8. Description of Work Accomplished

N3572T

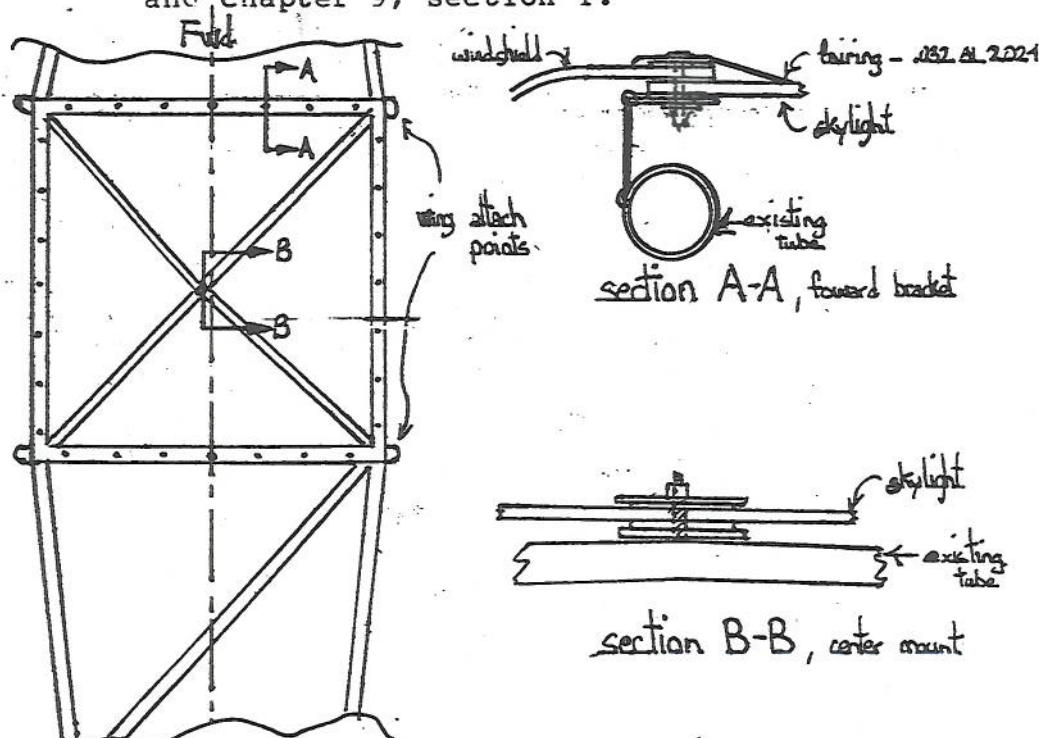
1. Replaced original aircraft fabric with acrylic skylight.

- A. Fabricated forward mounting bracket from .025" 4130 steel. The bracket is formed by welding two strips (1"x1.5") together at a 90° angle with a continuous bead. The bracket tapers to conform with the contour of the original skin. It is welded to the cross tube between the forward wing attach points every six inches.

- B. Fabricated aft and both side brackets from 3/8" 4130 steel U-channel. The side brackets are layed on the top-center of the existing longerons and welded in place every six inches. The aft U-channel is layed on the top-center of the existing cross tube between the aft wing attach points and welded every six inches.

- C. A #10-32x2" stud is welded to the center of existing X tubes.
- D. Skylight is fabricated from .125"x35.375"x31.5" clear acrylic. It is secured with seven evenly spaced AN510C-8 flathead machine screws per side. Aft mounts and sides utilize A8-75 Rivnuts. The forward mount utilizes MS21060-8 floating nut plates attached with AN442-3 rivets.

- D. All work done in accordance with AC43.13-1A, chapter 2, section 2 and chapter 9, section 1.
